DOCKETED	
Docket Number:	22-BSTD-01
Project Title:	2025 Energy Code Pre-Rulemaking
TN #:	247675
Document Title:	NRDC, Rocky Mountain Institute, Sierra Club Comments on Energy Accounting Workshop
Description:	N/A
Filer:	System
Organization:	NRDC
Submitter Role:	Public Agency
Submission Date:	11/23/2022 12:02:07 PM
Docketed Date:	11/23/2022

**NRDC, RMI, Sierra Club Comments on Energy Accounting
Workshop**

**Re: Comments on the Energy Accounting Workshop held November 10, 2022
(Docket No. 22-BSTD-01)**

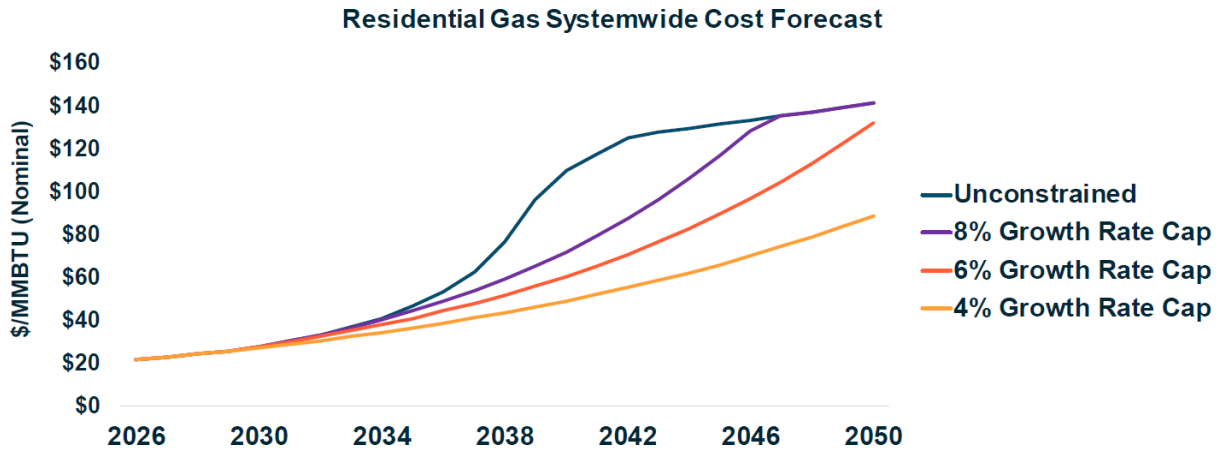
The High Electrification scenario results in a reduction in gas throughput, which combined with a moderately increasing revenue requirement, results in increased cost per unit of gas as shown in the figure below. This increased cost of gas reflects the reality of the reductions

in gas use needed to meet the state’s emissions reduction goals. However, the CEC has proposed an arbitrary 8% annual growth cap on gas costs. This unrealistically constrains gas price growth and will result in the installation of additional gas infrastructure, which will ultimately conflict with the financial interests of Californians, as early electrification is one of the key strategies identified to reduce the cost of achieving California’s climate goals.¹ Especially given the fact that the underlying scenario does not even achieve California’s climate goals, it is important to not arbitrarily limit gas price growth. We recommend removing this 8% cap and using the gas price forecasts predicted by the underlying scenario analysis.

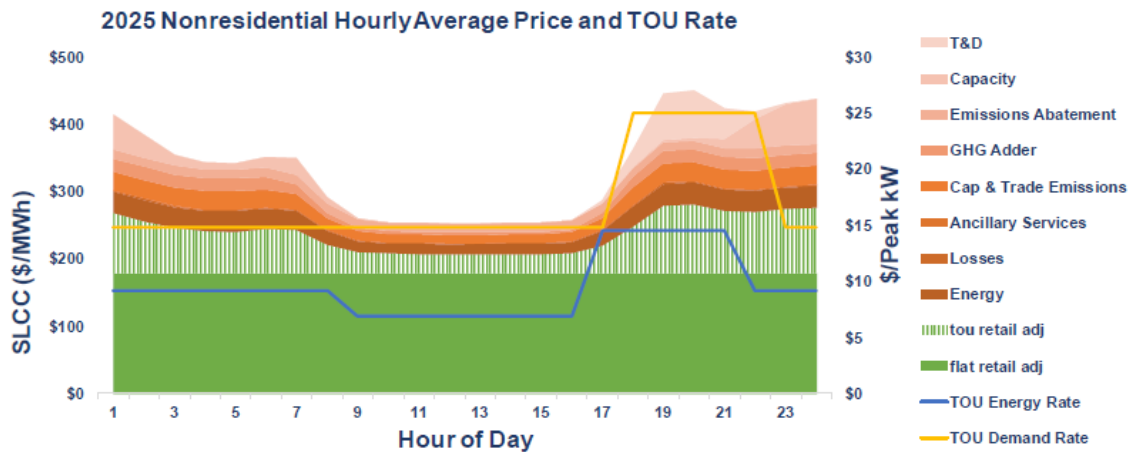
The majority of the time dependent valuation (TDV)² value comes from the retail adder, which is used to adjust the TDV values to meet electricity rate projections. The retail adder is further divided into a fixed component, which is flat, and a variable component, which varies proportionally to the other components of TDV, as shown in the figure below.

In the 2022 code cycle, the CEC assumed that 15% of the retail adder varied based on time of use and the rest was fixed for both residential and nonresidential buildings. For 2025, the CEC has proposed increasing the variable percentage of the retail adder to 25% for nonresidential buildings and maintain the 15% retail adder for residential buildings. We are directionally supportive of the increased variable component of the nonresidential retail adder and recommend that the CEC evaluate a higher variable percentage for the residential retail adder. We are unable to assess whether the specific percentages proposed for the variable component of the retail adder are appropriate as the TDV values have not yet been published; we therefore cannot evaluate the impact of the variable retail adder on measure selection. However, we are concerned that the values proposed, particularly for residential, do not align with the time of use rates Californians are likely to see. Values aligned with historical time of use rates are not likely to reflect the time of use rates that Californians will pay over the lifetime of buildings built to the 2025 code. California’s duck curve gets more pronounced every year and will continue to do so without complementary measures to shift load to low-demand hours. It is therefore critical that the TDV values adequately incentivize technologies that can shift load, store energy, and/or reduce load at peak times.
